Addendum #1

PROJECT: Fayette County Commissioners
Sheepskin Trail
Contract – 2/2024

ADDENDUM #1 – Contract 2/2024 – Sheepskin Trail Project

VEGETATED CHANNEL TYPICAL SECTION

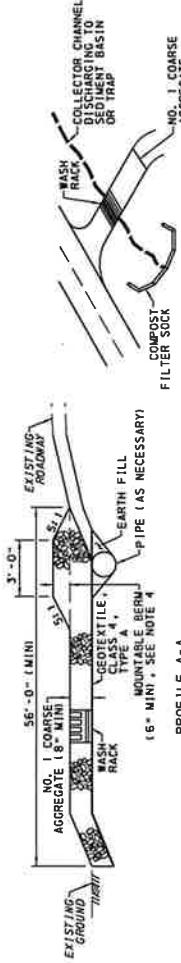
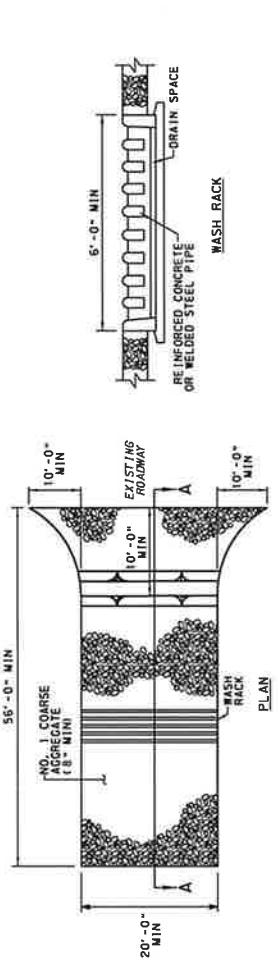
Please find the attached 2 updated sheets for the drawings/plans. These updated plans are due to a revision to the thickness of the amended soil depth.

5. CHANNEL CAPACITIES SHALL BE MAINTAINED AT ALL TIMES AND REPAIRS TO LININGS SHALL BE COMPLETED IMMEDIATELY.
6. THE AMENDED SOILS IS TO CONSIST OF THE FOLLOWING:

A. SAND - NOT LESS THAN 50% OR MORE THAN 55% OF THE TOTAL MIXTURE.
 B. SILT - NOT LESS THAN 25% OR MORE THAN 40% OF THE TOTAL MIXTURE.
 C. CLAY - NOT LESS THAN 5% OR MORE THAN 25% OF THE TOTAL MIXTURE.
